INTERIM CHANGE REQUEST

Plan Title/Rev. Unit 2 ISI Plan / Rev 1ICR No. ISI-2RI-02

ILLUSTRATIVE USE ONLY THIS DIAGRAM DEVELOPED FROM FLOW DIAGRAM M2-0256 SH A	
TU ELECTRIC CPSES UNIT 2	
INSERVICE INSPECTION BOUNDARY DIAGRAM	
CHEMICAL AND VOLUME CONTROL SYSTEM SHEET 12 OF 13	
REV 2	APPROVED: <i>golBoni</i> 5/3/96

COMANCHE PEAK UNIT 2
INSERVICE INSPECTION PLAN
CLASS 1 SCHED/COMPL COMPONENTS

RELIEF REQUEST
B-3

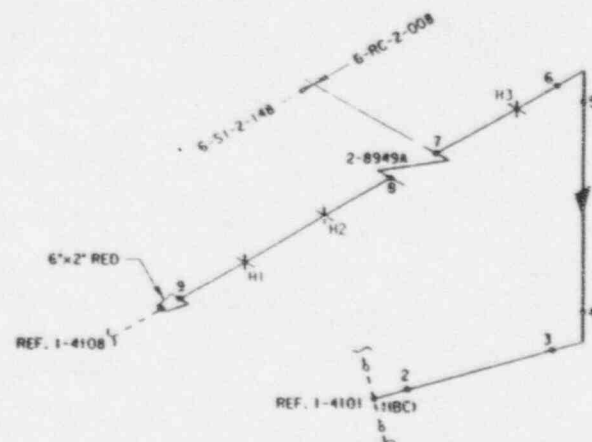
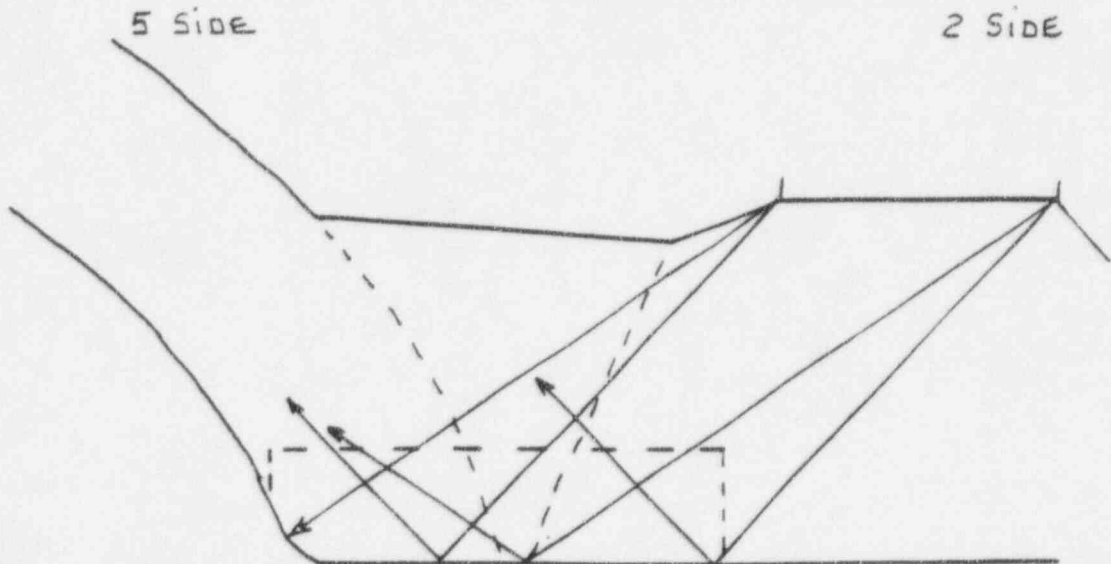
TCX-1-4104-1
Branch Pipe Connection Weld

The requirement for volumetric examination of 100% of the weld length as described in Table IWB-2500-1, Examination Category B-J, Item No. B9.31.

The specific examination area geometry of this pipe to branch connection weld precludes the complete ultrasonic examination of the volume required by Fig. IWB-2500-10. Approximately 23% of the examination volume did not receive the full code required coverage.

A best effort examination was performed. Full circumferential scan coverage was obtained. Axial scan coverage was achieved in one beam path direction with at least one beam angle for 100% of the examination volume (see pages 2 & 3).

23% OF THE REQUIRED EXAMINATION VOLUME IS NOT COVERED IN 2 BEAM PATH DIRECTIONS.

100% OF THE REQUIRED EXAMINATION VOLUME IS COVERED IN AT LEAST 1 BEAM PATH DIRECTION.
